# SERVICE BULLETIN

TR-2400

830

SUBJECT: TR-2400 TX NOISE

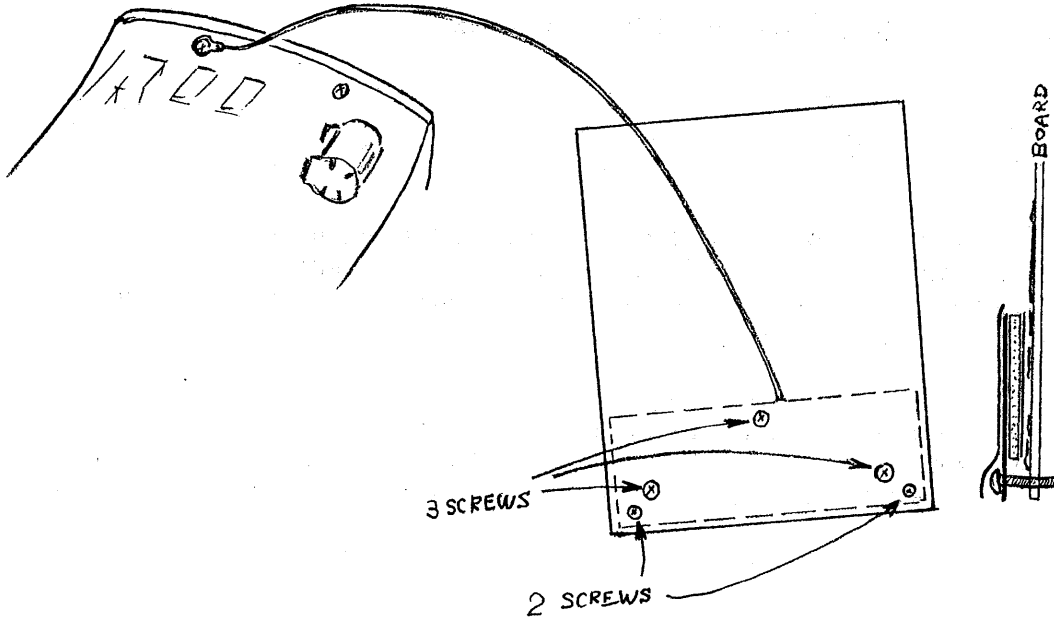
Some units may exhibit excessive background noise (up to several hundred Hertz deviation). This may be reduced or eliminated by installing an additional shield between the Display and PLL units.

This change applies only to units between serial numbers 011xxxx and 101xxxx. Radios before this group (with a momentary REV switch) will not show improvement by addition of this shield. Refer to Service Bulletin 815 for this early group.

N09-0627-05 Pan head screw 3 pcs.  
F10-1627-04 Shield w/lead 1 pc.

1. Remove 4 rear case screws, and 2 screws from inside the battery compartment.
2. Separate front case from body. DON'T tear leads.
3. Remove 2 small and three large screws from the bottom edge of the Display unit. Save the two small screws.
4. Install the three pan head screws in place of the round head screws.
5. Install the shield foam towards the Display. Lift the protective plastic only enough to secure the shield with the two small screws. Cover the screw heads with the plastic film.
6. Secure the shield ground under the small Phillips screw located between the BUSY/OPEN and S TONE switches.
7. When reassembling, the wiring harness must be positioned to the right of crystal X2 (46.1666MHz) or the case will not close correctly, and wires will be pinched.
8. Close the case and reinstall 6 screws.
